Cause/Reason for Change:

Standard product series review and upgrade. Updated packing method for higher volume quantities.

AOCJY

Part Number Builder:

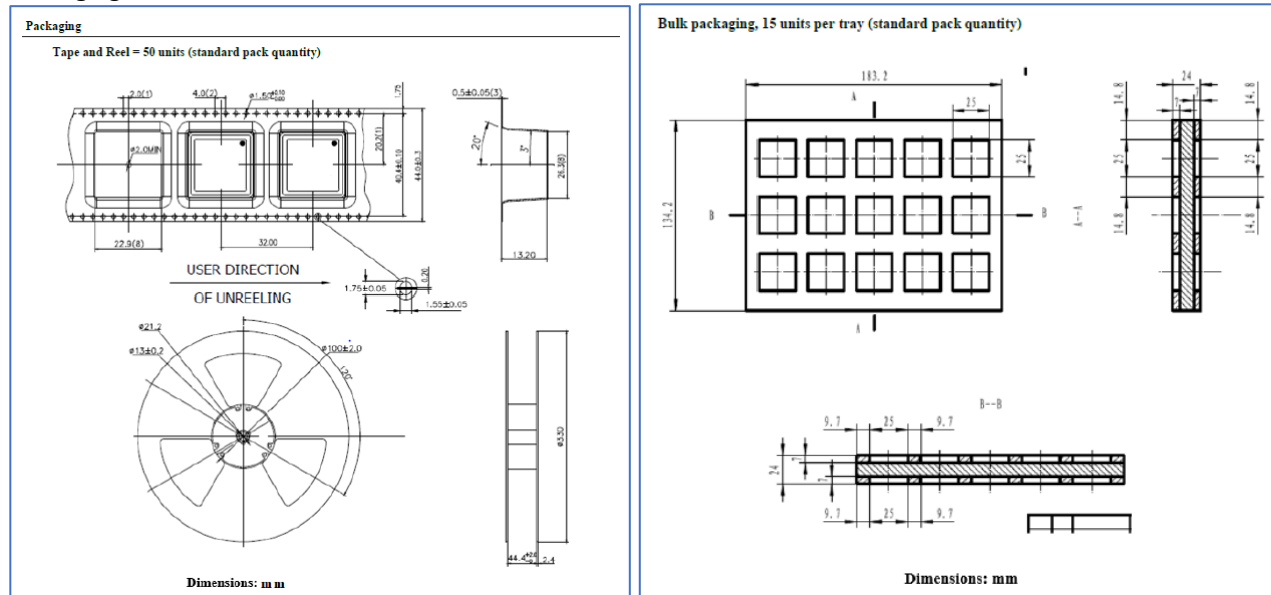
After Change:

Packaging:

This change does not affect the electrical nor mechanical performance of this product.

Packaging

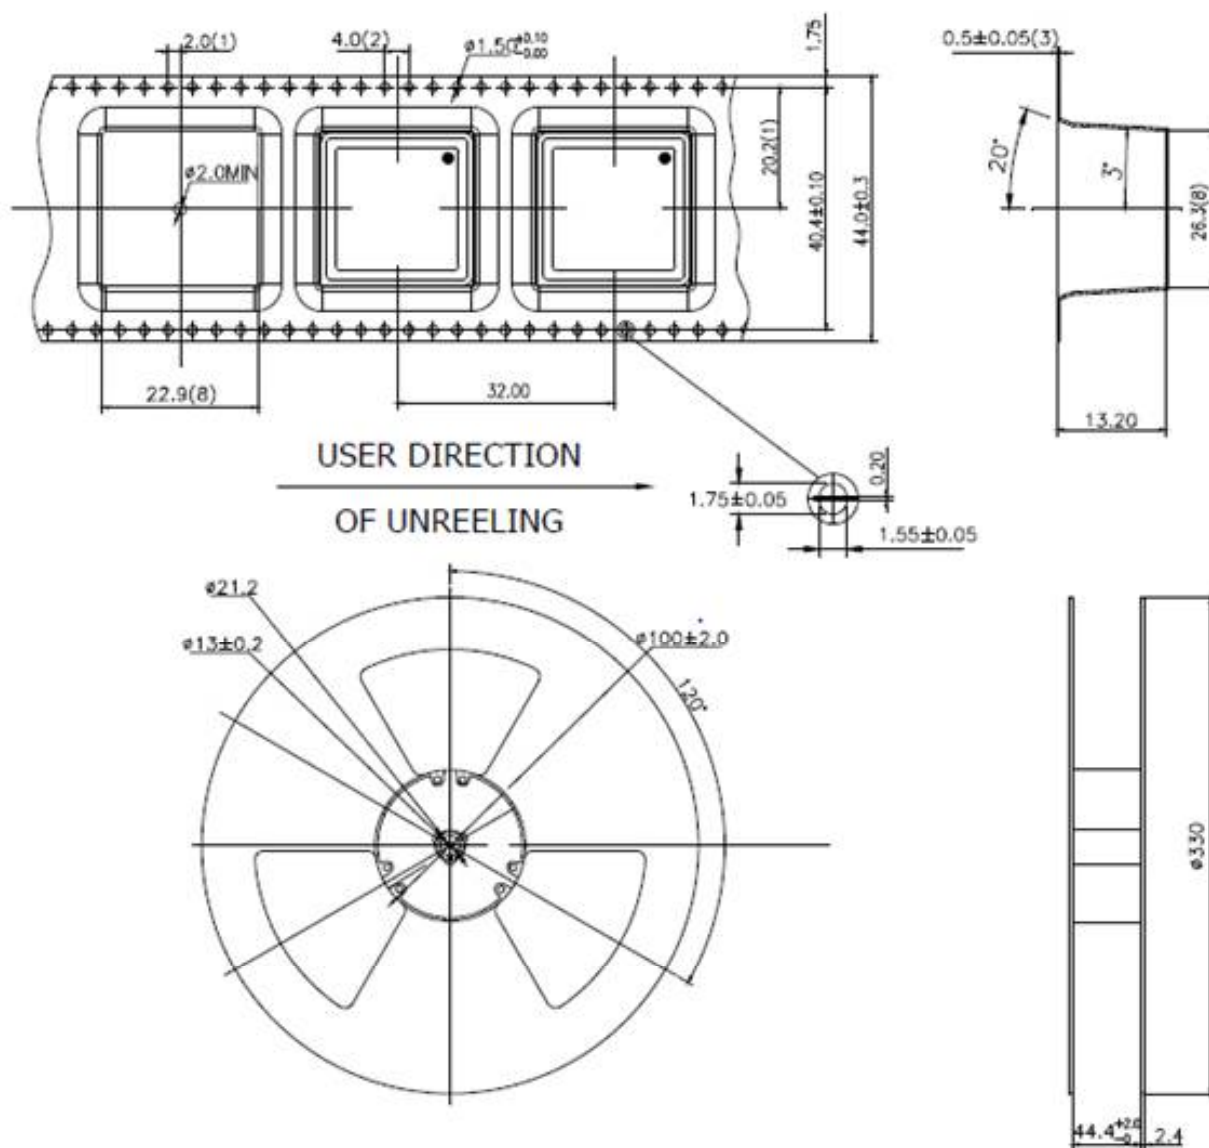
Tape and Reel = 50 units (standard pack quantity)

Packaging *continued*

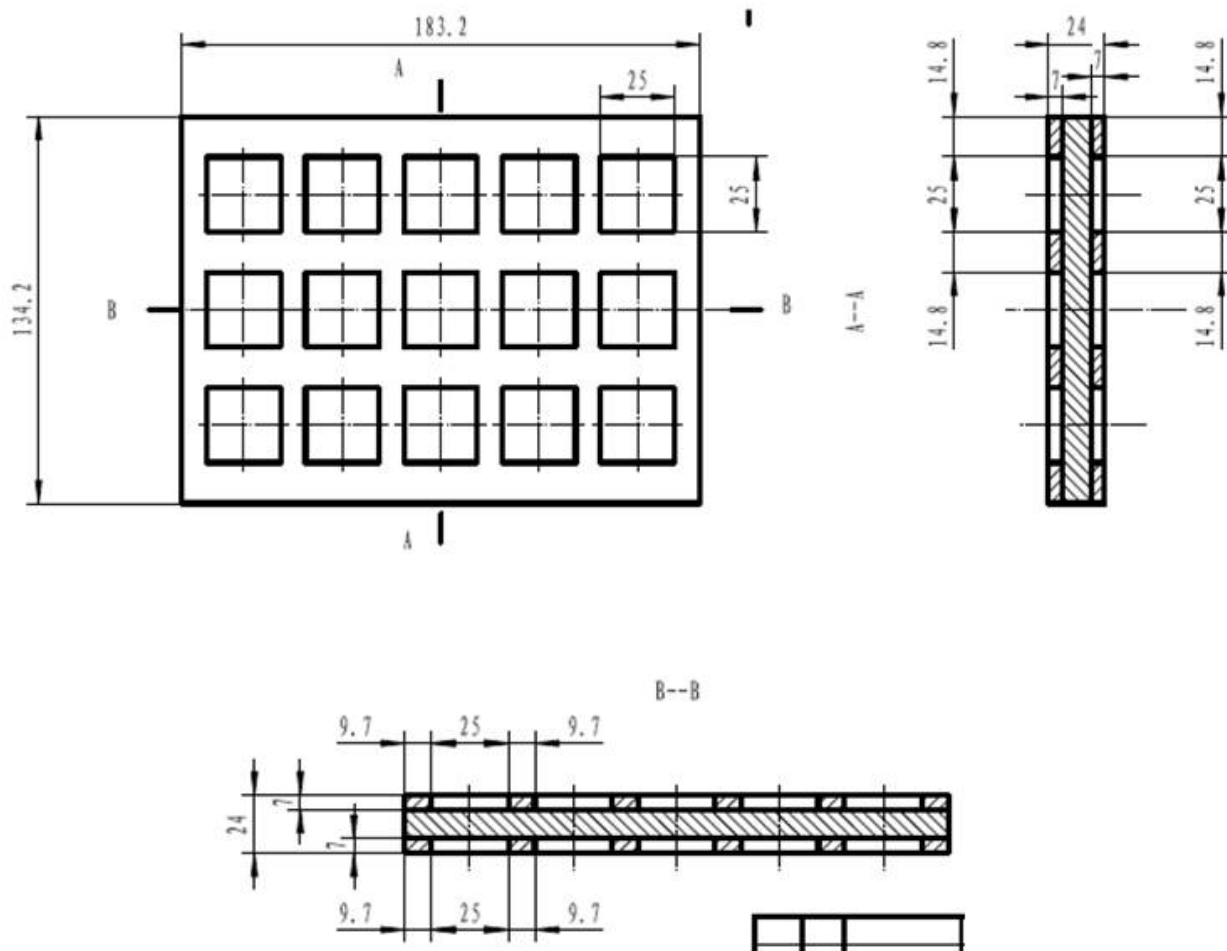
Bulk packaging, 15 units per tray (standard pack quantity)
